<p align="center">CDM: Form for Submissions on Small Scale Methodologies and Procedures (version 03) <i>(To be used for presenting questions/proposals/amendments related to the simplified methodologies for small-scale CDM project activity categories)</i></p>	
Name:	Luca Morganti Institution: First Climate Group
Affiliation ¹ :	<input type="checkbox"/> DNA <input type="checkbox"/> DOE <input checked="" type="checkbox"/> PP <input type="checkbox"/> Stakeholder
Title/Subject (max. 200 characters):	Request for revision of AMS.III.Q to include multiple fuels in the baseline electricity source and multiple waste heat sources
Purpose of the submission:	<input type="checkbox"/> Query on an approved SSC methodology or small scale procedures ² (Fill in field 1. below) <input checked="" type="checkbox"/> Request for Revision of an approved SSC methodology (Fill in fields 2. and 3. below) <input type="checkbox"/> Proposal for a new SSC methodology (Fill in fields 4. and 5. below)

Approved SSC methodologies ² to which your submission relates to, if applicable.	AMS.III.Q Waste energy recovery (gas/heat/pressure) projects
Contact Information (e-mail addresses to which the answers are to be deliv

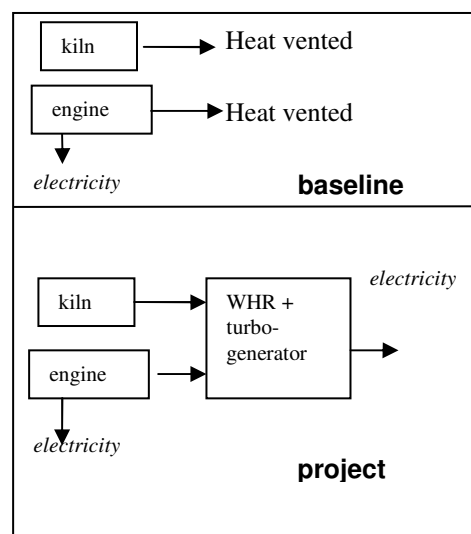
In a case of a cement factory waste heat is collected from the kiln AND from an internal combustion engine. Although steam is generated in separate waste heat recovery boilers, it is fed to the same steam turbine to produce electricity.

Whereas the waste heat from the kiln is heat from an elemental process and it is eligible under the methodology, the heat from the internal combustion engine is not. Using the waste heat from the internal combustion engine would constitute a combined cycle as electricity is generated in a second step, after the primary fuel has already been used to generate electricity in the internal combustion engine.

The project activity is therefore a mix of a single-cycle (heat from elemental process, i.e. kiln) and a combined-cycle (heat from engine). Furthermore, the heat from the engine has no other useful application on site (would be vented) and is only utilisable to produce power. This case seems to be excluded by clause 6.c cited above.

However, clause 6.c seems to be geared towards single-cycle power plants (and not captive power units) where waste heat cannot be used for anything else than further power generation in a combined cycle. Footnote number 10 in ACM0012 refers to the identical clause. There it is stated that ACM007 is to be applied in such cases. Both, ACM0012 and ACM007 relate to power plants and are not intended to be applied to industrial on-site electricity production.

It is here requested to amend the methodology to distinguish between power plants and industrial captive power units. We propose to change clause 6.c in order to be applicable to full scale power plants with the main purpose to provide electricity to the grid (as intended by ACM0007) but excluding single power generation units within a captive power plant serving a manufacturing plant:

“The projects recovering waste energy from such power plants for the purpose of generation of heat only can apply this methodology, as well as do single-cycle captive power units (e.g. serving manufacturing plants) where waste heat cannot be used for anything else than further power generation”
